**WATERMARK COAL PROJECT**

**RESPONSE**  
**to Planning Assessment**  
**Commission Review Report**

for  
**Shenhua Watermark Pty Limited**  
October 2014

## WATERMARK COAL PROJECT RESPONSE TO PLANNING ASSESSMENT COMMISSION REVIEW REPORT

Department of Planning and Environment ZOA

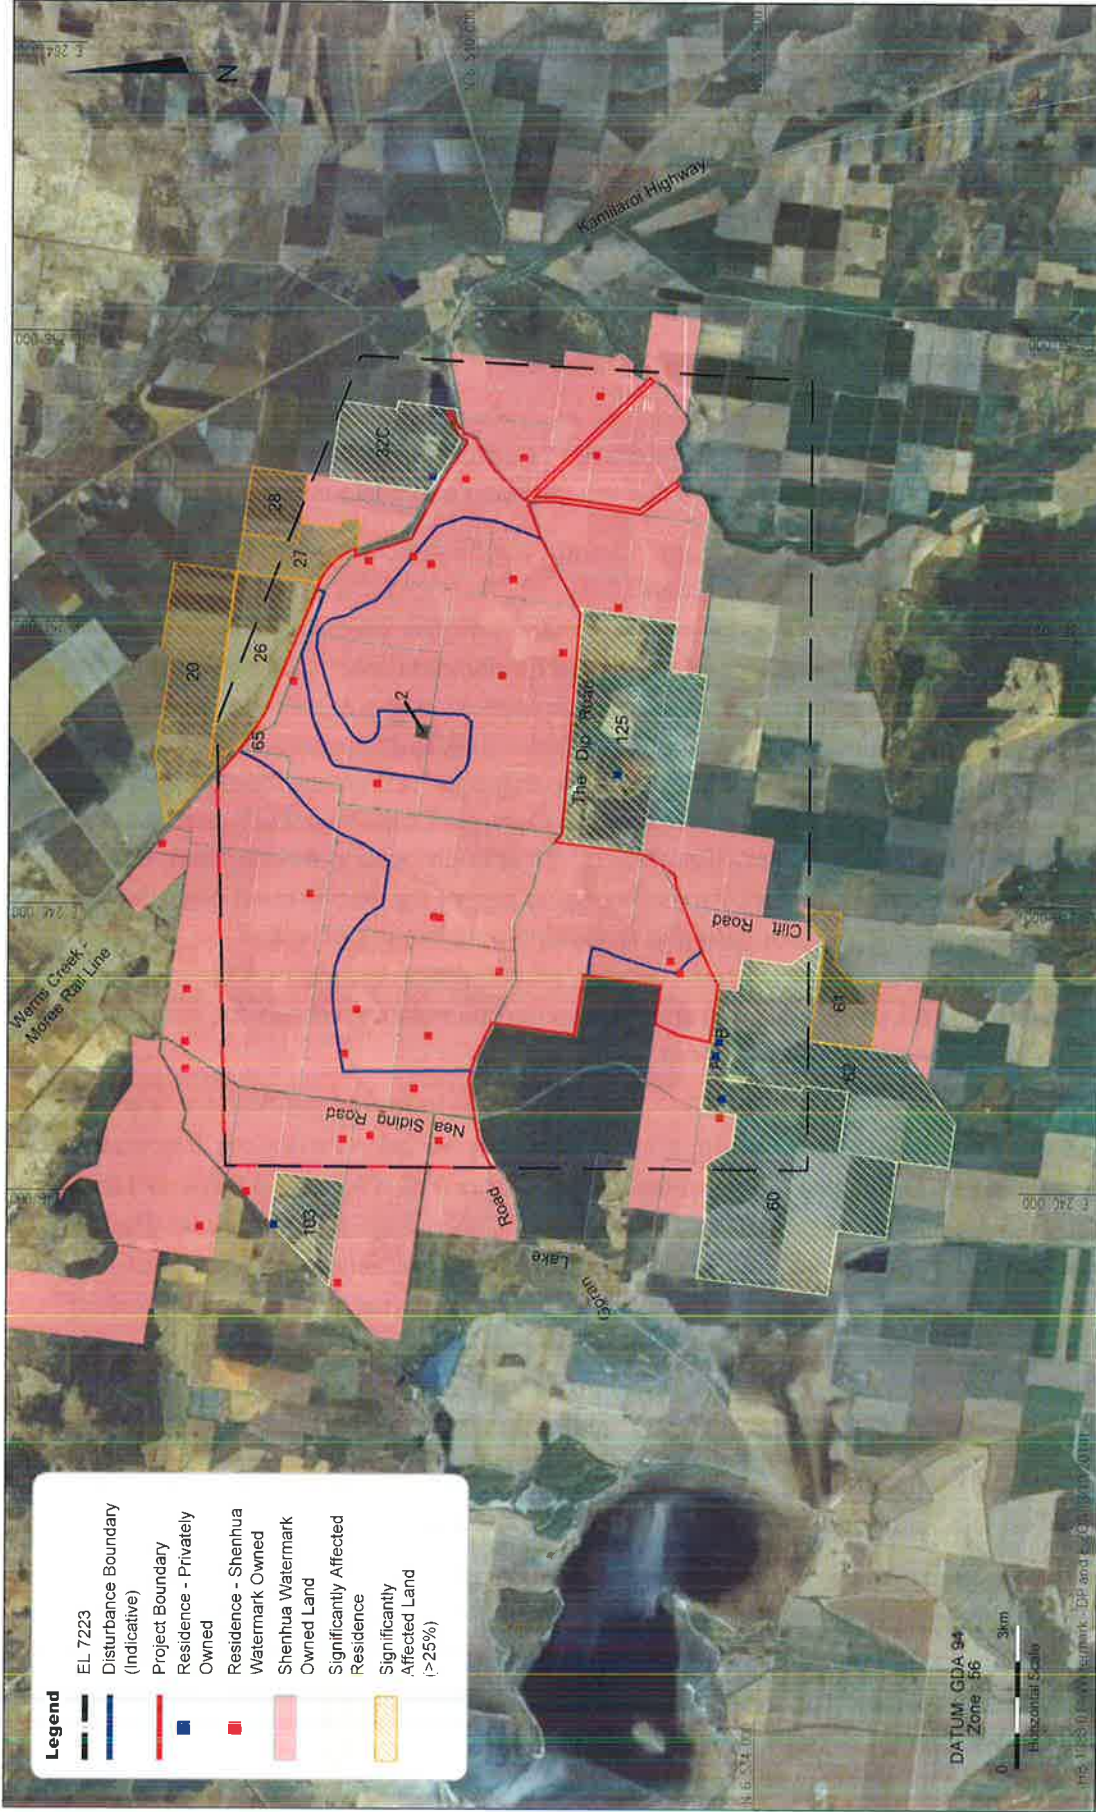
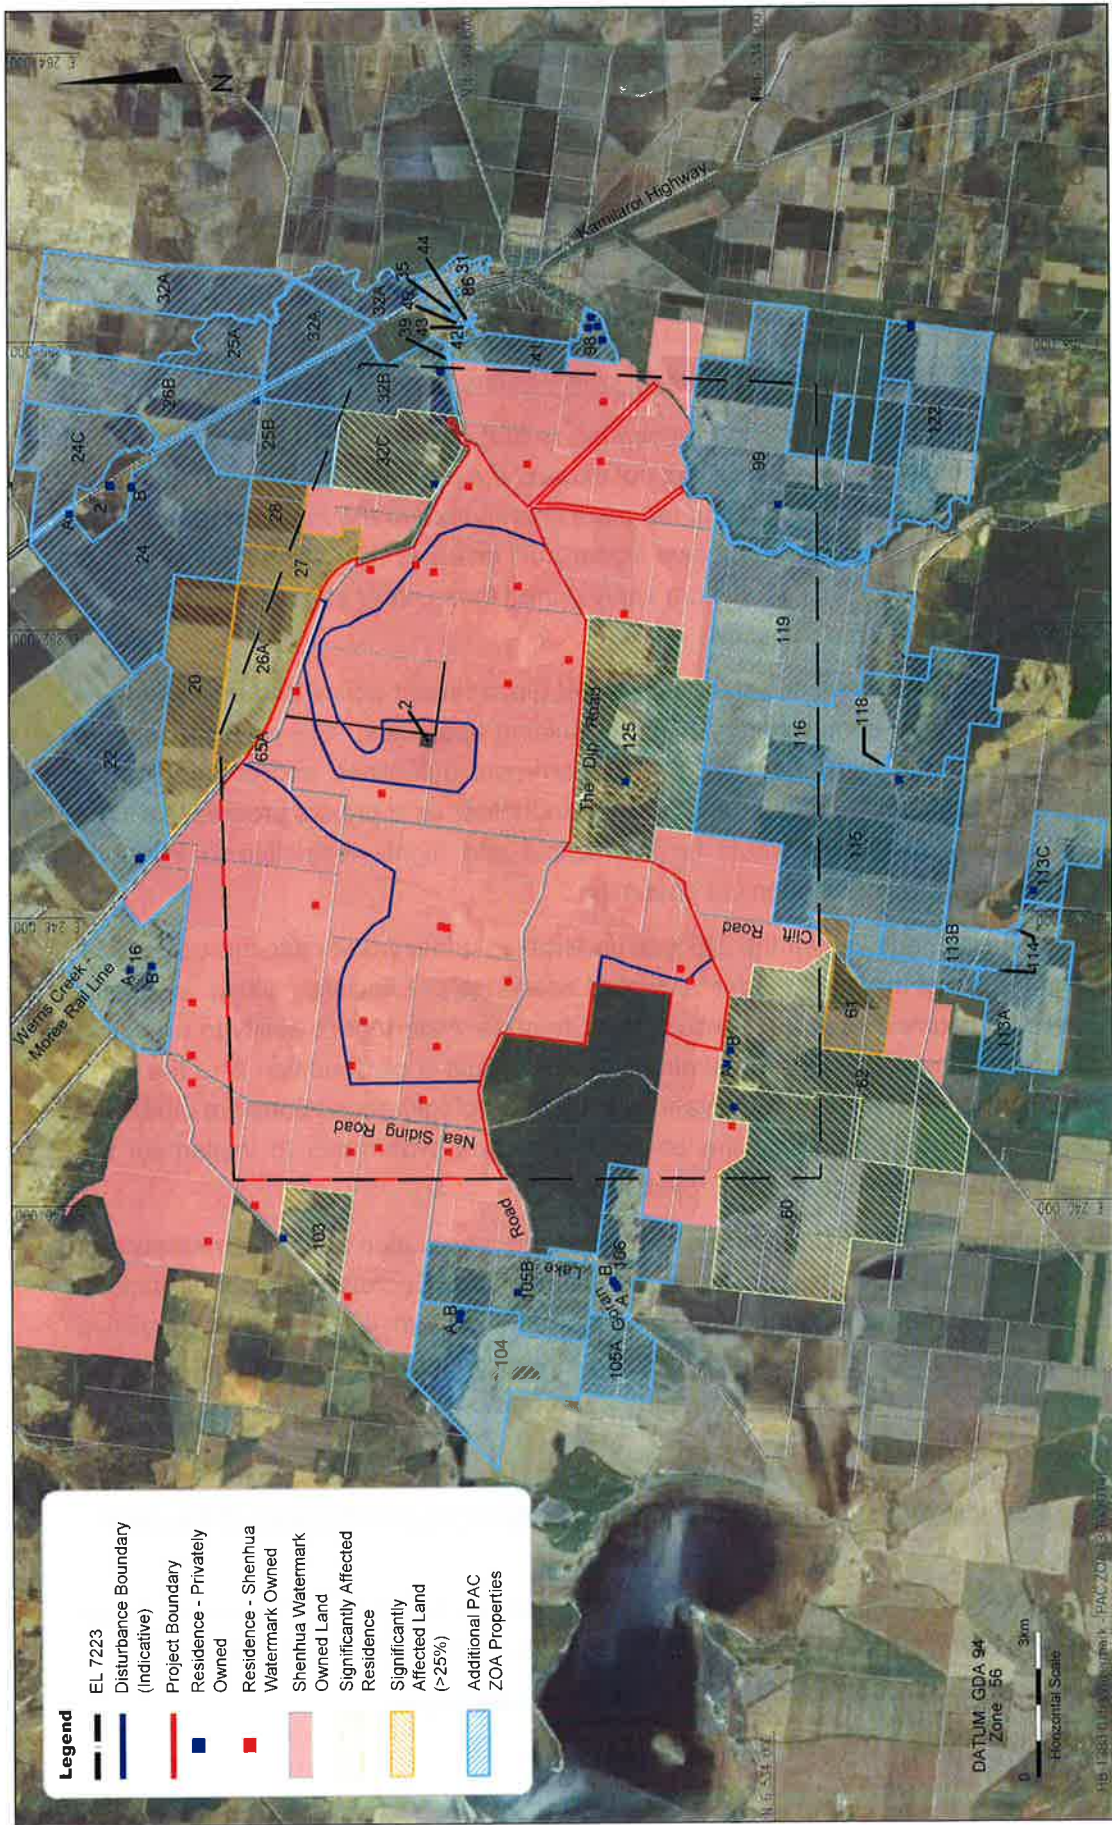
**Figure 2** presents the far more extensive ZOA as suggested within the PAC Review Report which if implemented, would include vast areas of black soil plains extending over 8 km from the Project. The proposition that this huge swathe of land will be impacted by dust and or noise beyond recognised amenity levels is inconsistent with contemporary NSW Government policy and the assessments carried out to date.

Shenhua Watermark supports the findings of the Secretary's Environmental Assessment Report in relation to an appropriate ZOA for the Project (see **Figure 1**).

As previously stipulated, Shenhua Watermark supports the ZOA proposed in Table 8 of the Secretary's Environmental Assessment Report (as shown on **Figure 1**) which is consistent with other comparable open cut coal mining developments.

**Figure 2-2 Cross-section of potentiometric head vs model layers (Backfilled model drain scenarios)**

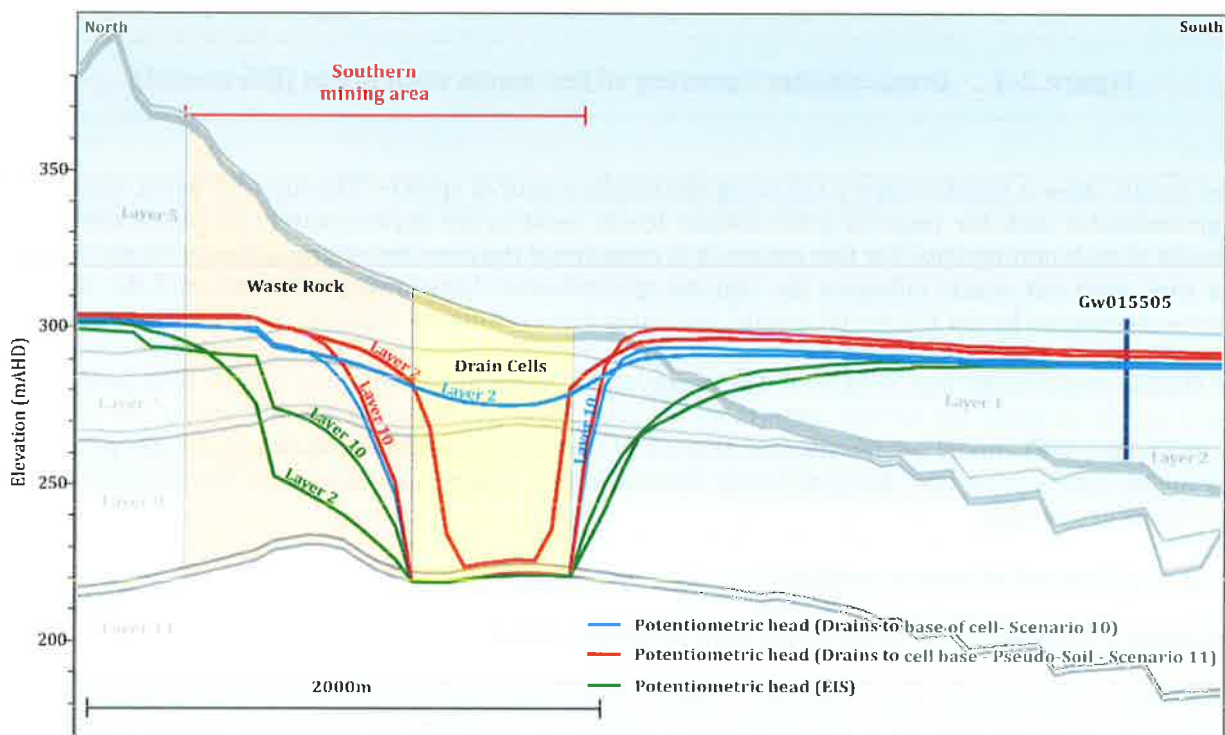
The backfilled and non-backfilled model have been re-run to demonstrate the sensitivity of the drain reference elevations to the predicted impacts. Figure 2-2 shows the difference in potentiometric heads in layer 2 and layer 10 in the backfilled model at Year 23 using:

- EIS model - drain reference elevations to the bottom of Layer 10 (green);
- Scenario 10 - drain reference elevations to the base of the cell (blue); and
- Scenario 11 - drain reference elevations to the bottom of each cell with the pseudo-soil function (red).

The results show that varying the drain reference elevation influences the predicted heads using the staged backfilling approach. The method employed in the EIS model results in increased drawdown immediately adjacent to the pit wall, which in turn implies that more water enters the drain cells. Setting drain cell elevations to the base of each cell floor results in steeper hydraulic gradients adjacent to the pit walls, and therefore a more rapid recovery in groundwater levels behind the active mining area, which is progressively backfilled with spoil. This indicates that setting drain cell elevations to the base of each cell reduces the regional groundwater impacts predicted by the model.

**Figure 2-8 Pit seepage sensitivity to Hclose – (Scenario 0)**

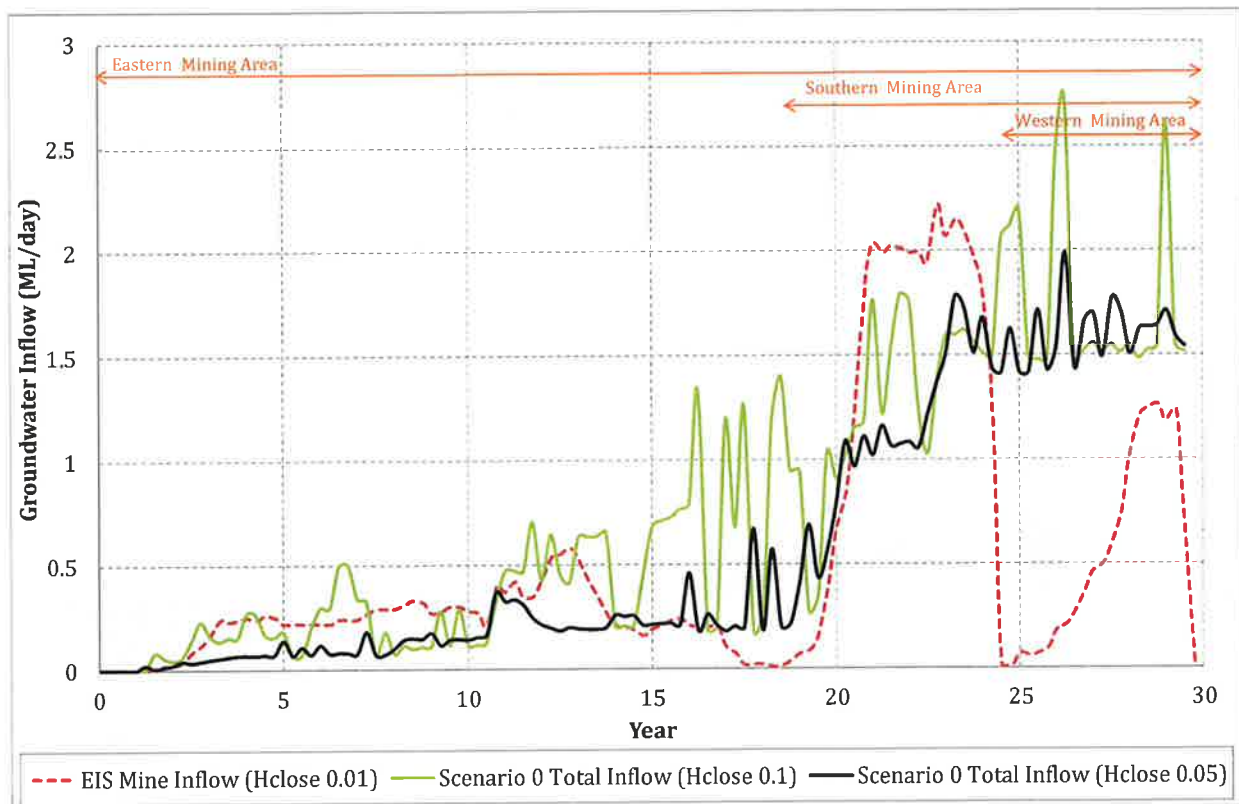
Dr Mackie noted “While the EIS inflows exhibit a relatively smooth trend line, the same cannot be said for the WST (non-backfilled) model where highly erratic behaviour is evident for the Eastern and Western pits. This erratic behaviour includes correlatable ‘spikes’ in the inflows across all three pits simultaneously (red arrows) suggesting underlying instability or abnormal behaviour in the model which needs to be resolved.”

The non-backfilled model (scenario 0) has been re-run using a tighter maximum head change criteria of 0.05 m to assess the changes to the groundwater inflow budgets. Figure 2-8 compares the pit inflow from the EIS model with the non-backfilled model applying two different closure criterion.

The results suggest that in order to obtain a pit seepage accuracy of  $<\pm 0.1$  ML/day, the percent error at any time step for the Watermark model should not exceed 0.03%. The EIS model produced percent discrepancy errors of less than 0.01% at any time step, and therefore using this loosely based logic relevant to the non-backfilled model, mine inflows could be considered accurate to approximately  $\pm 0.03$  ML/day.

**Figure 2-12 Cross section of water table surface (EIS model)**

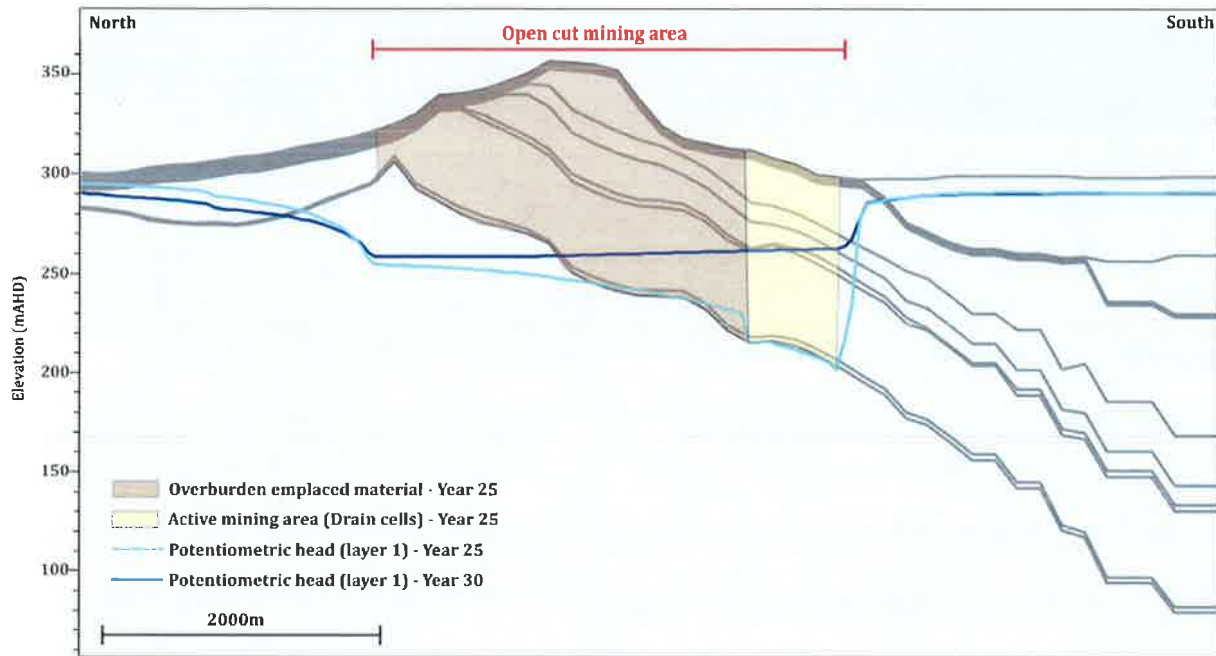
Dr Mackie also noted that: *“Figure 6 represents the EIS model with pore pressures indicated by the white contours. Close inspection of the zero pore pressure (water table) contour in the Southern Pit shows a highly erratic surface. Normally are relatively smooth surface that reflects the floor of the mined coal seam, would be expected (see Figure 7 for dewatered pit profile). The erratic surface identified in Figure 6 may be indicative of more general problems probably associated with recharge to spoils, or to unconventional assignment of drain cells or possibly discretisation issues. It is important to identify the reason for this behaviour since it may have implications for regional water table drawdown and mine water inflows.”*

Upon analysis of the groundwater potentiometric heads, there is no visible erratic behaviour of the groundwater potentiometric surface throughout the model run. AGE provided Dr Mackie a figure which represented a model cell pressure head, which was contoured against the finite difference cell centres in the groundwater model. As such, the zero pressure contour represented an interpolated saturation surface, which was intended to display absolute saturation extents rather than represent the saturation surface. Graphical user interfaces (e.g. Groundwater Vistas 6) perform additional corrections in cells experiencing unconfined conditions ensure the zero pressure head contour is equal to the water table.

Figure 2-12 shows the water table surface at years 25 and 30 for the EIS model. Clearly, there is no erratic behaviour in the groundwater levels, and the re-saturation of groundwater levels in the waste rock appears realistic.
